ORIGINATION FORM

Proposed Revisions to a Standard Plans Index
(Please provide all information — Incomplete forms will be returned)

Index Number: 715-001
Sheet Number (s): 1 OF 3
Index Title: Conventional Lighting

Summary of the changes:

INDEX	SHEET
715-001	1 of 3

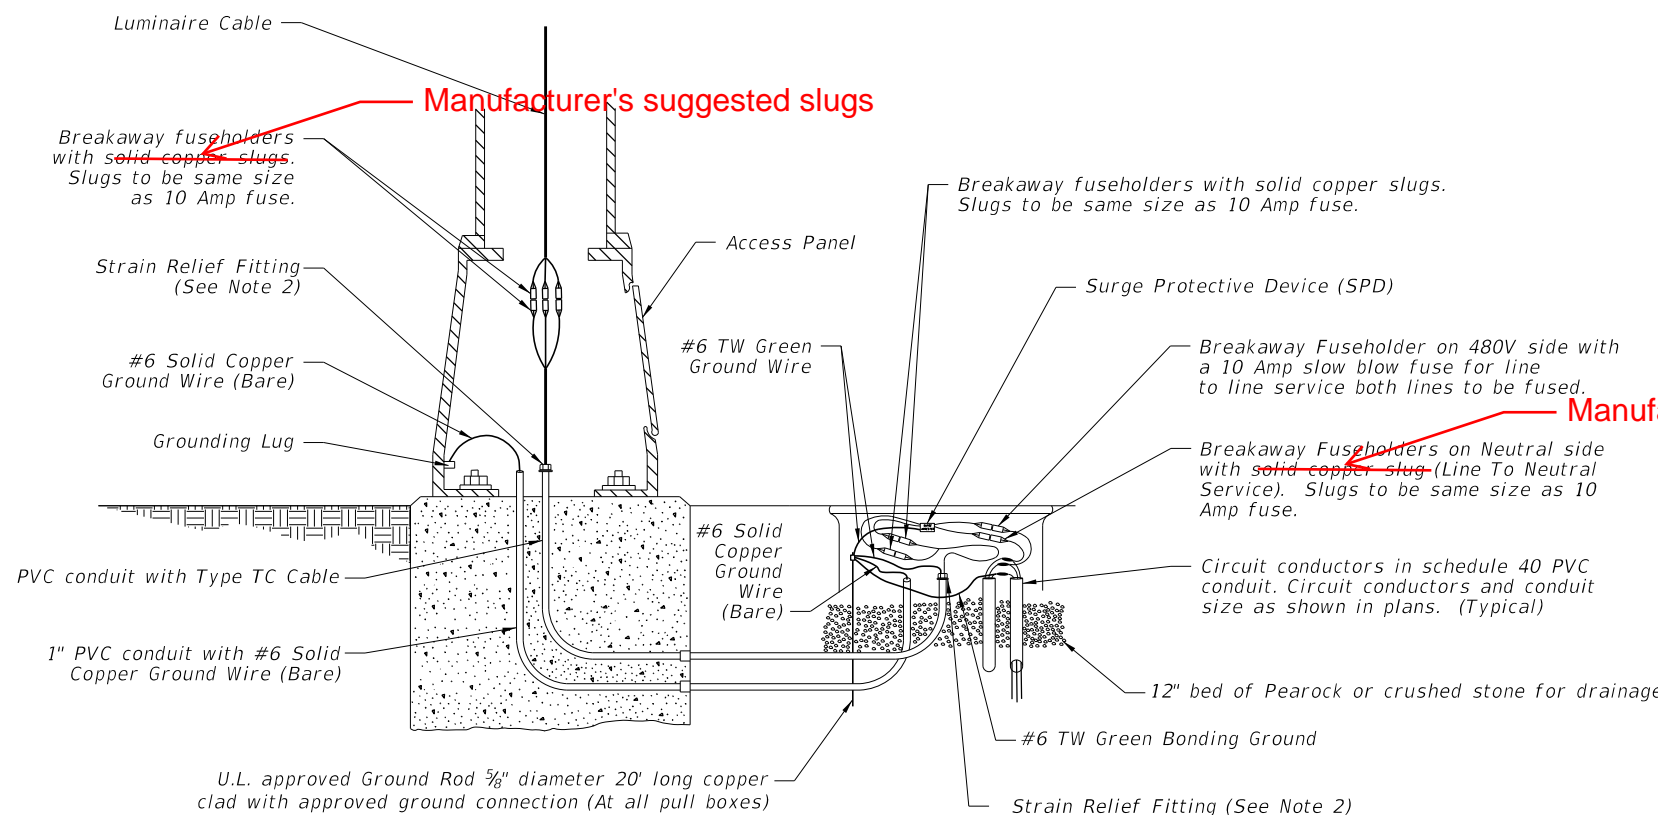
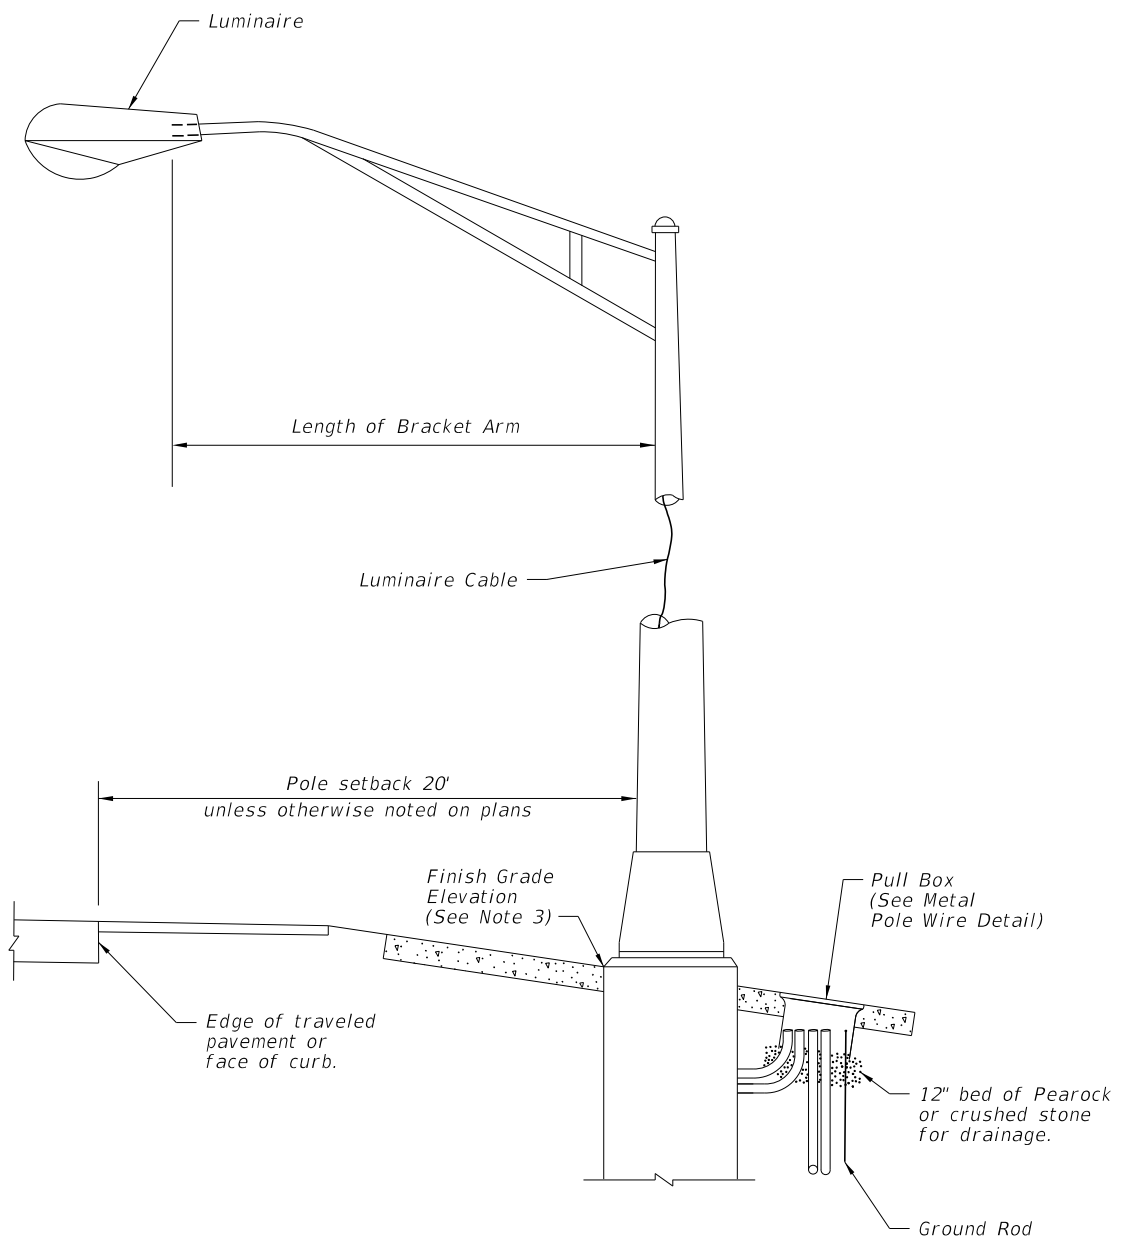
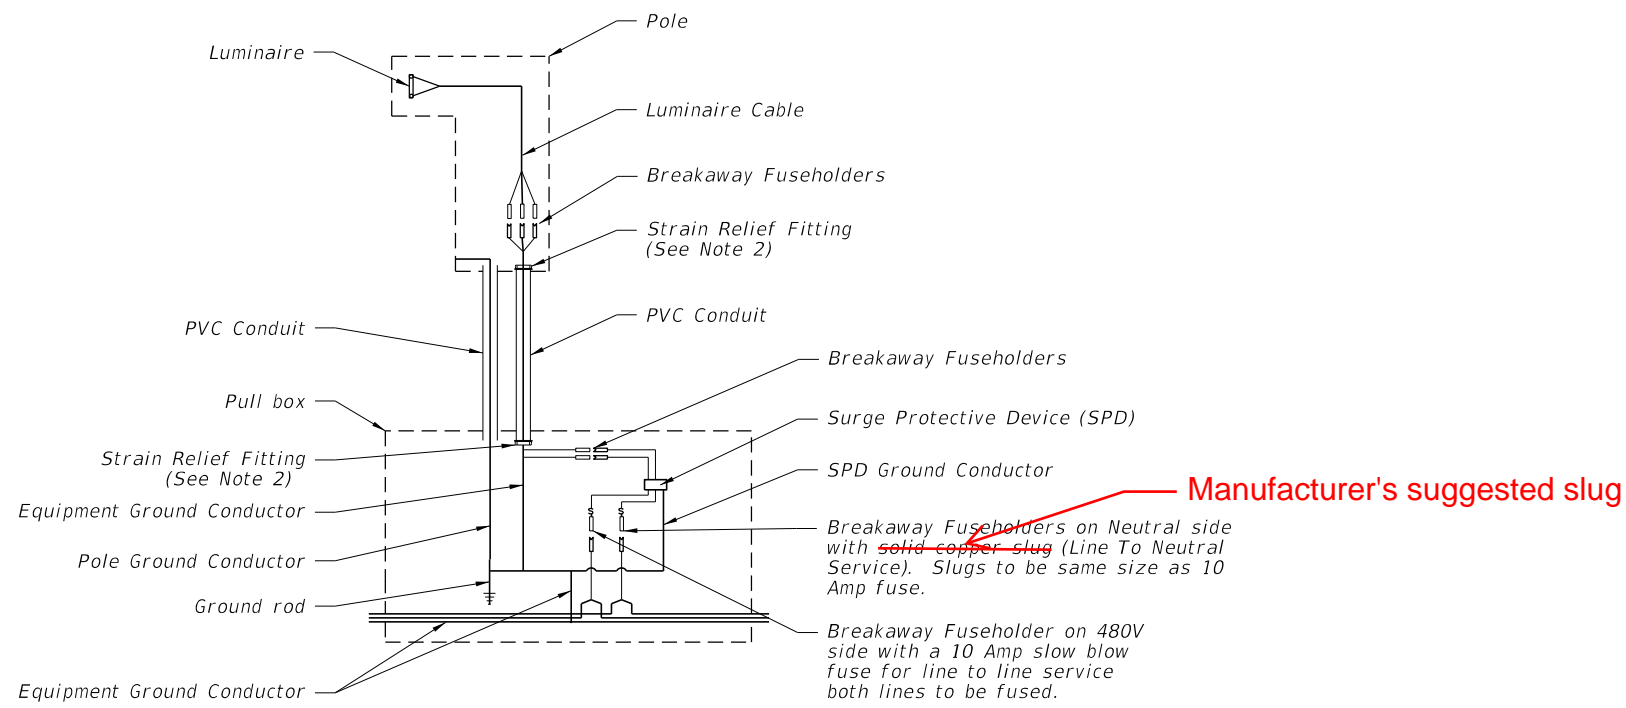
Sheet 1: Changed fuse holder slug (blank) requirement from solid copper to manufacturer's suggested in three drawing locations.

Industry advised that solid copper slug requirement is impractical and uncommon. Specification 992 is being revised to require the fuse holder manufacturer's suggested slug of copper equivalent (manufacturer generally responsible for performance of their product). This Standards change reflects the Specifications change.

Manufacturer's suggested slug

Manufacturer's suggested slug
